BLACKHAWK COUNTY
 BRIDGE REPLACEMENT
 BRFN-218-7(239)--39-07
 LETTING DATE
 11/21/2023

PLANS OF PROPOSED IMPROVEMENT ON THE
PRIMARY ROAD SYSTEM
BLACKHAWK COUNTY

BRIDGE REPLACEMENT
 Replacement of the US 218 Bridge
 Over Mud Creek, ~~0.4 mi. South~~
~~of the junction with I-380.~~
 SCALES: As Noted

FIELD EXAM NOTES

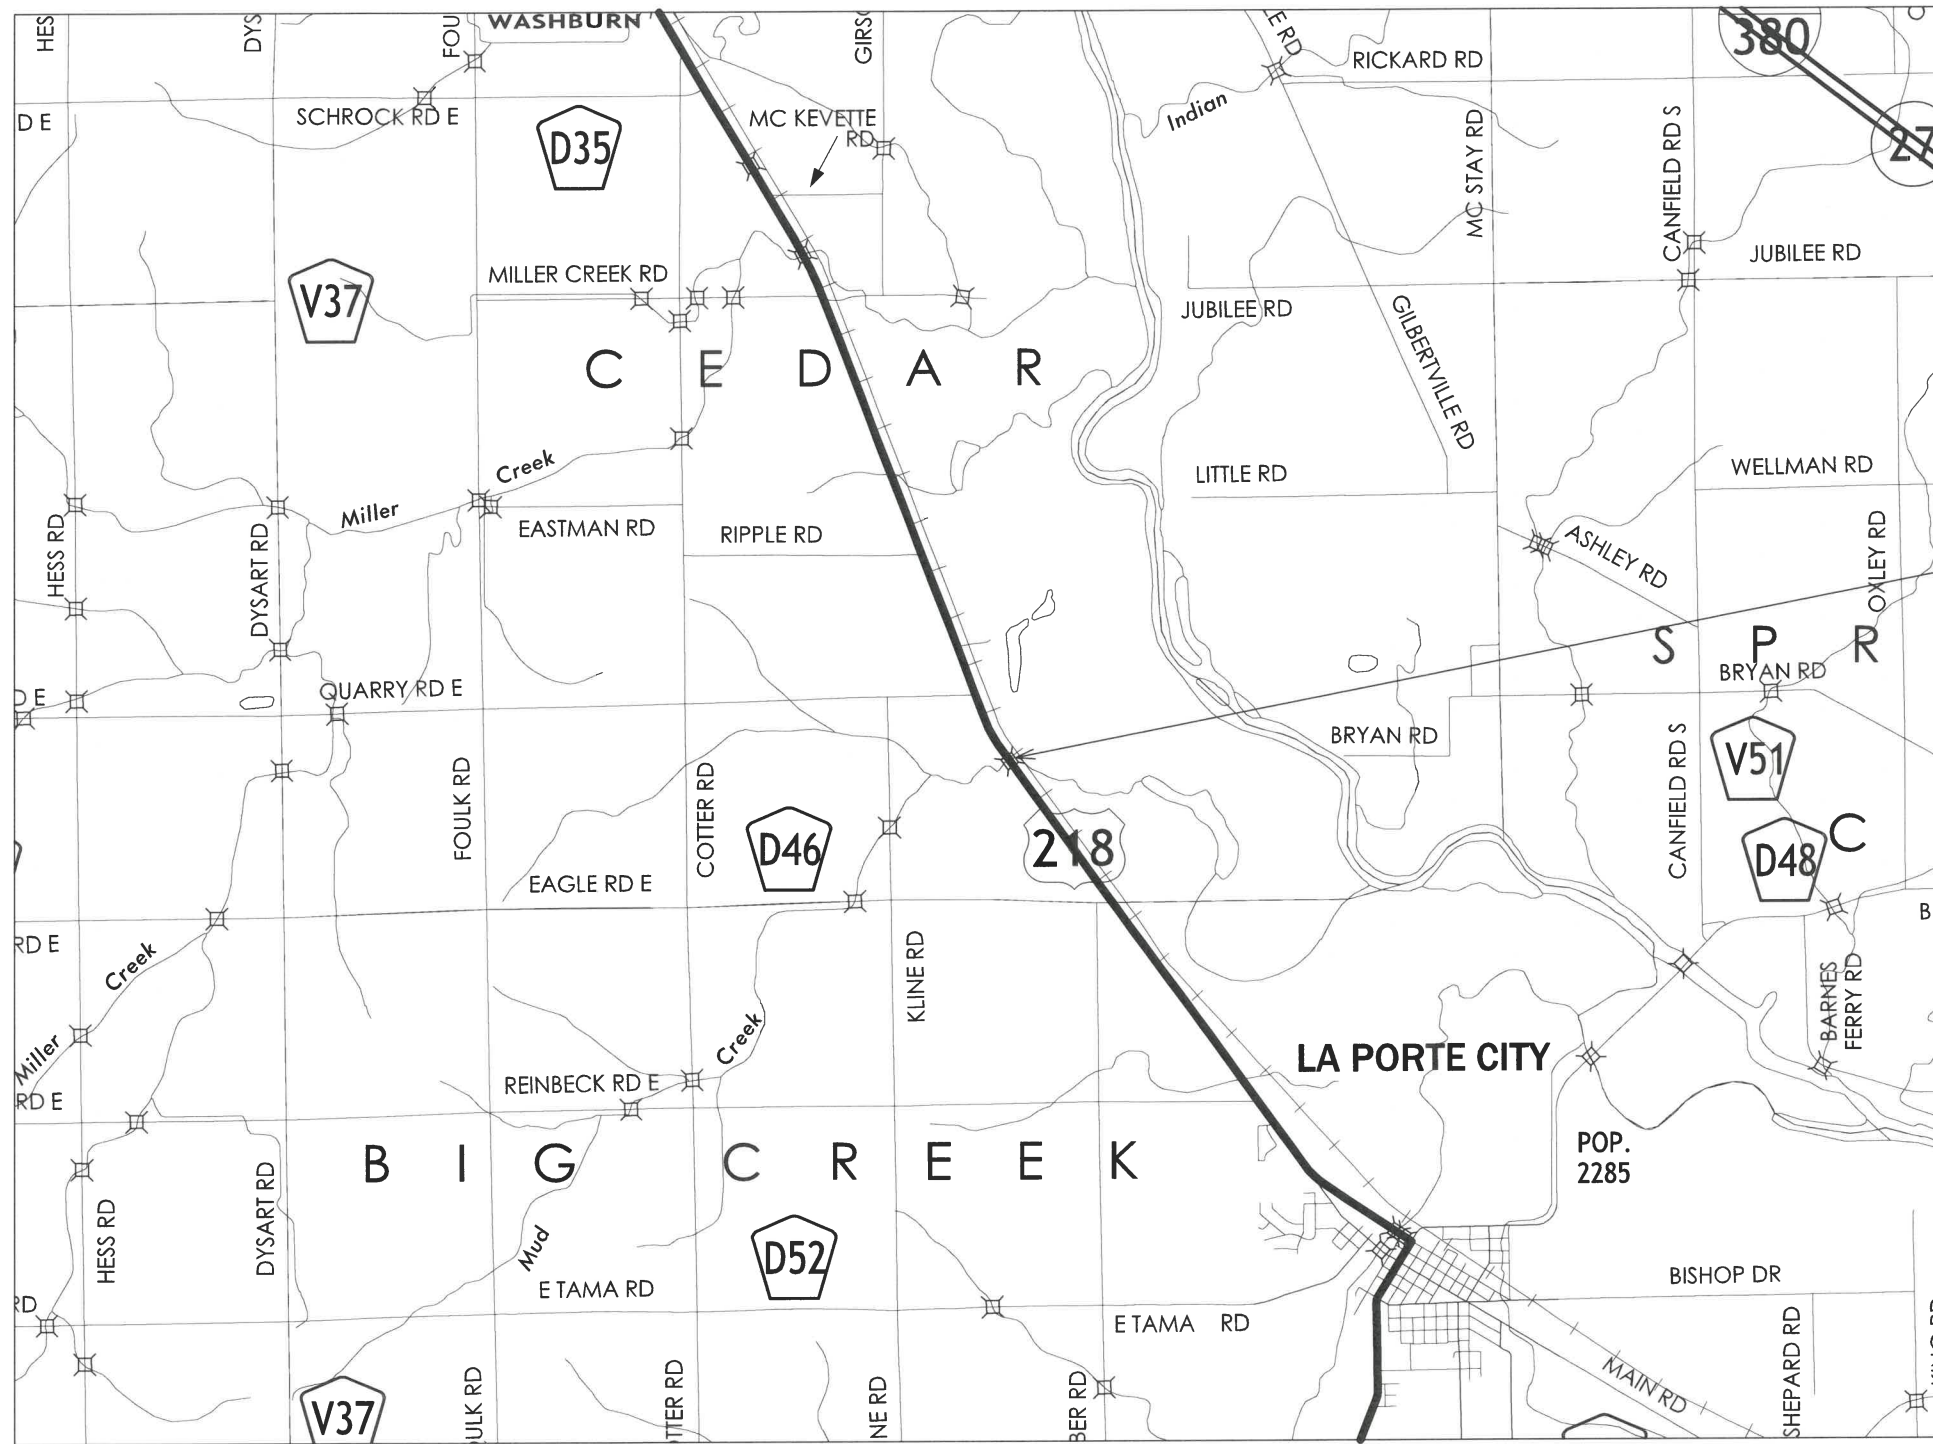
0.9 mi. North of
 Co. Rd. D46

DESIGN FOR 0° SKEW
130'-0 X 40'-0 CONTIN. CONCRETE SLAB BRIDGE

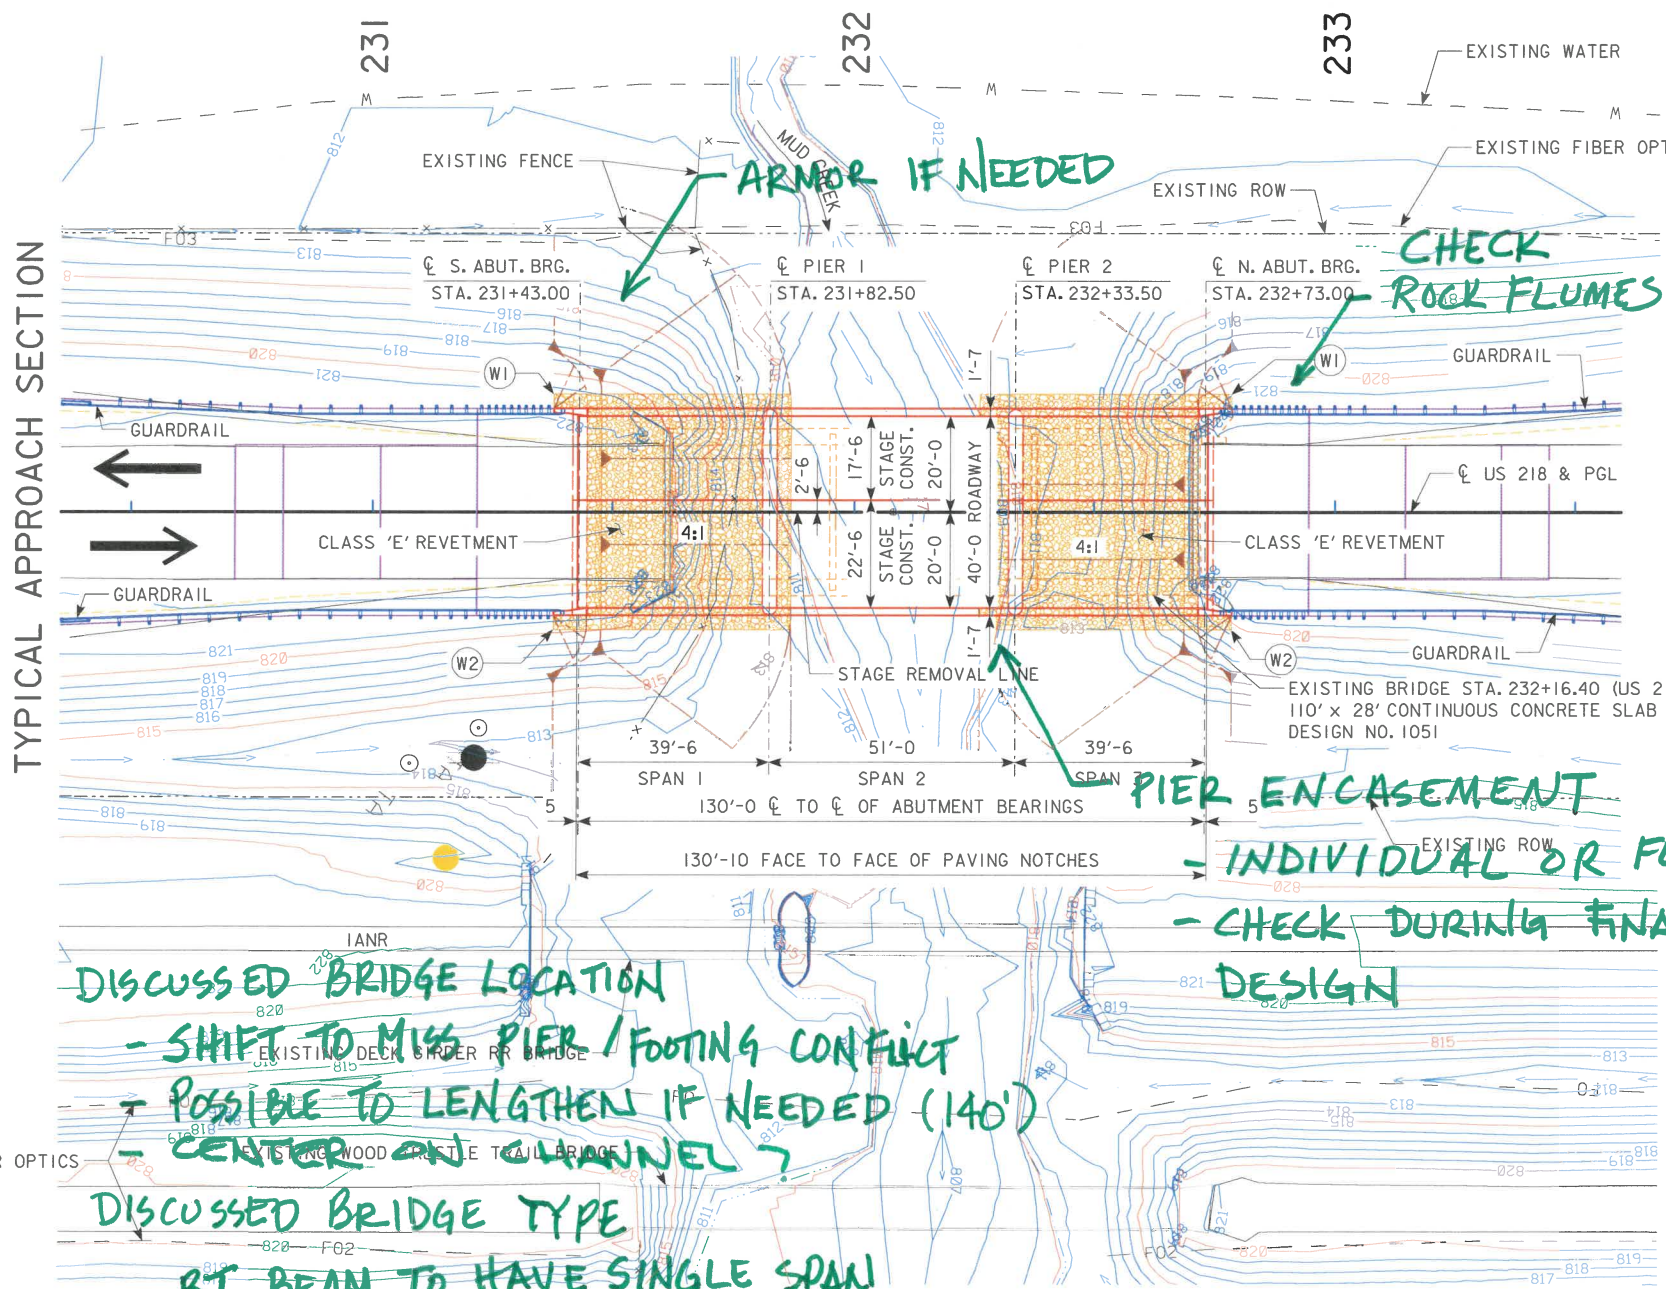
DISCUSSED BRIDGE LOCATION
 - SHIFT TO MISS PIER / FOOTING CONFLICT
 - POSSIBLE TO LENGTHEN IF NEEDED (140')
 - CENTER ON CHANNEL?
DISCUSSED BRIDGE TYPE
 - BT BEAM TO HAVE SINGLE SPAN
 - HYDRAULIC CONSTRAINT?

SITUATION PLAN

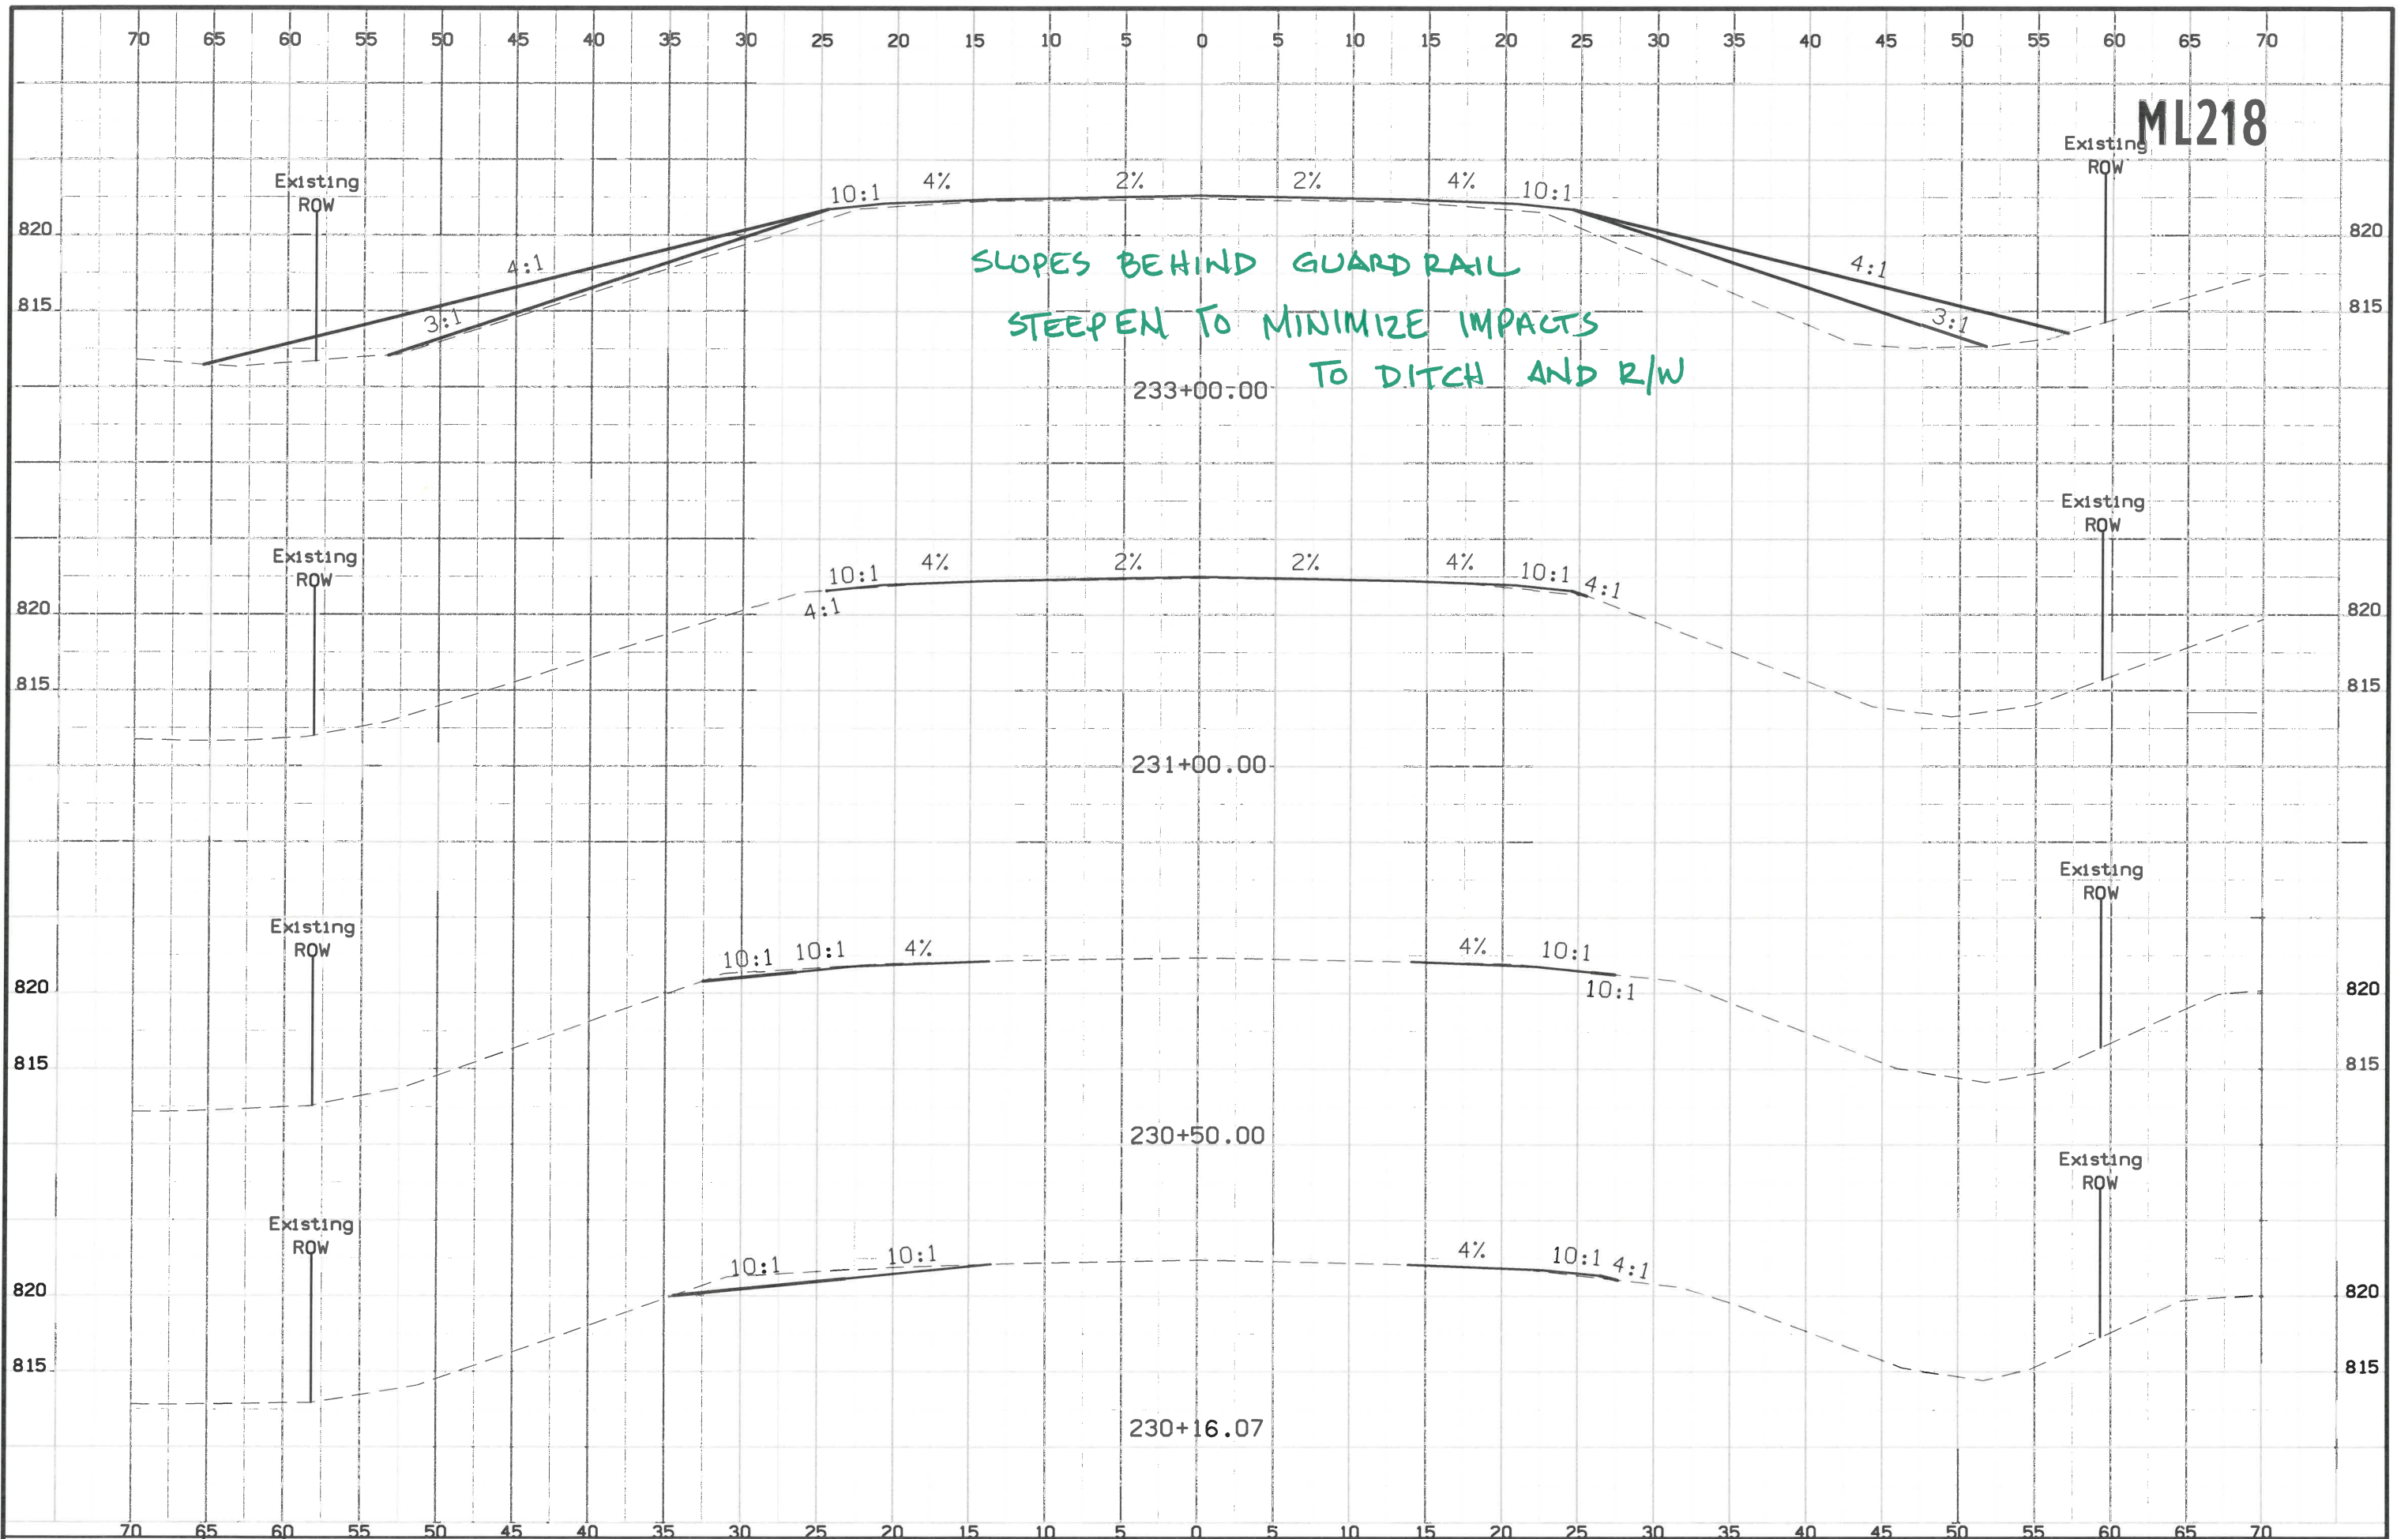
SLOPES BEHIND GUARD RAIL
 STEEPEN TO MINIMIZE IMPACTS
 TO DITCH AND R/W
